APPENDIX D
BLAST IMPACT
RESPONSE TO PAC REVIEW REPORT

COALPAC PTY LTD

PAC REVIEW – BLAST MANAGEMENT RESPONSE

Adrian J. Moore
5th March, 2013

FIGURE J4.4.2.1 TRANSIENT VIBRATION GUIDE VALUES FOR COSMETIC DAMAGE (BS 7385-2)

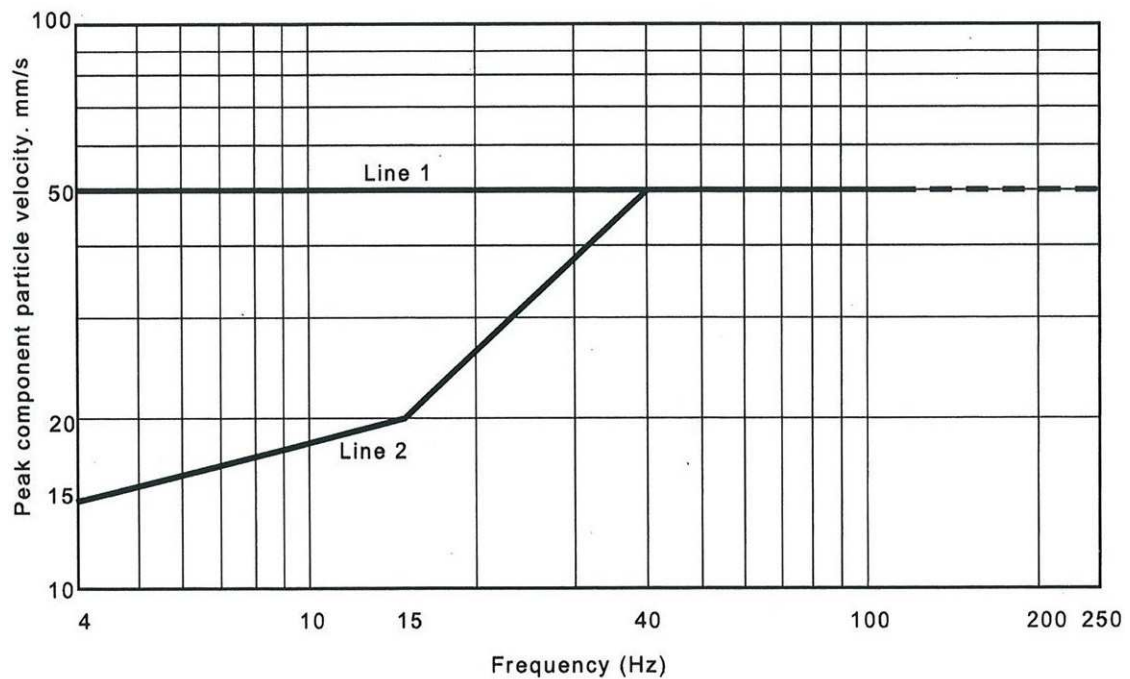
For a typical house the limits for cosmetic damage are 15 mm/s at 4 Hz increasing to 20 mm/s at 15 Hz.

For the usual exposure range of 10 – 15 Hz, which is appropriate for the Contracted Project, the damage control limits for Residences range from 18 mm/s to 20 mm/s. At 18 – 20 mm/s we may expect the start of the formation of hairline cracks and the growth of existing cracks in
